Access Compliance Report

Public Rights-of-Way

(Curb Ramps)

Intersection ID: 46303	Main Street: HONEY_CREEK_LN	Cross Street: MERMANS_RD	Location: NW
ADA ID: 11D32228EB95	Ramp Type: Perp	Initial Pass/Fail: Fail	Overall Compliance: No
Severity Score: 22.5			
Codes/Mitigation Info/Possible Solution		Field Measurements/Component Compliance

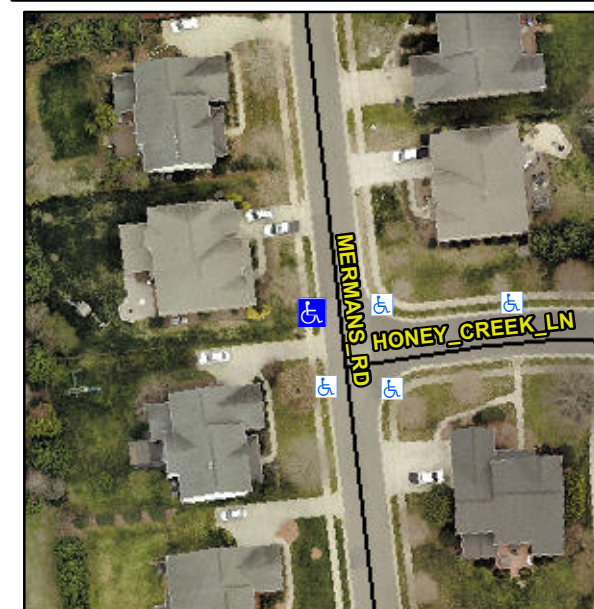
Not Found, R304.5.1, R304.2.2, R304.5.3

Compliance	Description	Data	Compliance	Description	Data
N/A	Ramp Length (in)	47.0	No	Ramp Slope (%)	8.4
No	Ramp Width (in)	47.0	No	Ramp XSlope (%)	2.6
N/A	Flare Type LT	N/A	N/A	Flare Type RT	N/A
N/A	Flare Slope LT (%)	N/A	N/A	Flare Slope RT (%)	N/A
N/A	Flare Traversable LT?	N/A	N/A	Flare Traversable RT?	N/A
N/A	Landing Length (in)	N/A	N/A	DWS Provided?	N/A
N/A	Landing Width (in)	N/A	N/A	DWS Contrast?	N/A
N/A	Landing Slope (%)	N/A	N/A	DWS Length (in)	N/A
N/A	Landing X Slope (%)	N/A	N/A	DWS Full Width?	N/A
N/A	Landing Curb? (Y/N)	N/A	N/A	DWS Offset (in)	N/A
N/A	Shared Landing?	N/A			
N/A	Gutter Ponding?	N/A	N/A	Gutter Slope (%)	N/A
N/A	Gutter Lip Ht (in)	N/A	N/A	Gutter X Slope (%)	N/A
N/A	Painted X Walk1?	No	N/A	Painted X Walk2?	N/A
	X Walk 1 Direction	To E		X Walk 2 Direction	N/A
N/A	X Walk 1 Width (in)	N/A	N/A	X Walk 2 Width (in)	N/A
	X Walk 1 Slope (%)	4.1		X Walk 2 Slope (%)	N/A
	X Walk 1 X Slope (%)	0.7		X Walk 2 X Slope (%)	N/A

Remove & Replace Entire Ramp.
